Discovery 2010 Announcement of Opportunity Q&A Updated September 3 2010

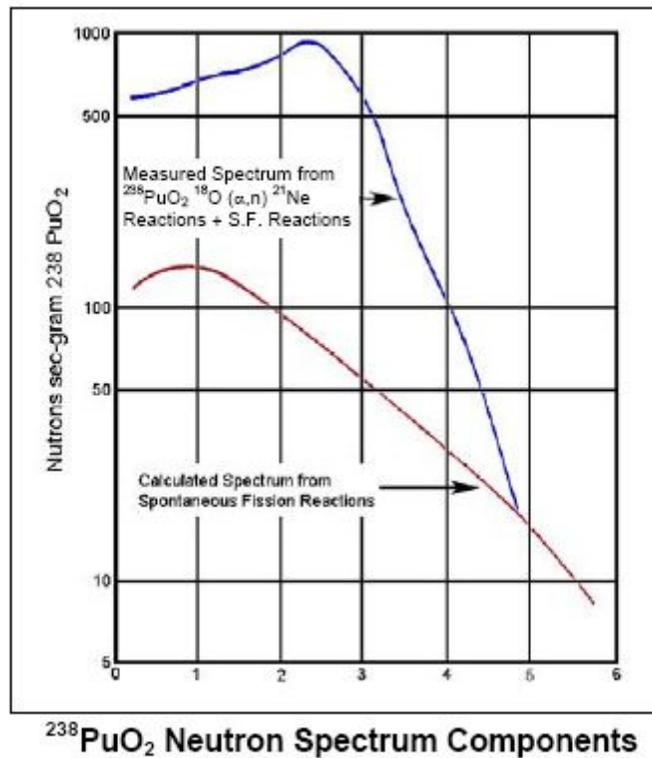
AR-8 *The first paragraph of Section 2.2 of the ASRG Information Summary in the Program Library document states that “Proposers should use...a system mass of 25 kg for planning purposes...” Using the definitions of Requirement B-34 on page B-16, should the 25 kg identified for the ASRG mass be used for the “current best estimate” or the “max expected?”*

The updated current best estimate (CBE) with design margin is 28.0 kg. The mass has grown due to additional levied requirements by NASA. The Program is holding a 5% reserve on the 28 kg, thus 29.5 kg should be used for planning purposes. This reserve will be released as the ASRG design gates PDR and CDR are achieved.

Margin is defined here to accommodate design known unknowns and reserve is for accommodating unknown unknowns. The masses for the ASRG to spacecraft (S/C) mounting plate and controller cable are not included since these items are mission or S/C specific.
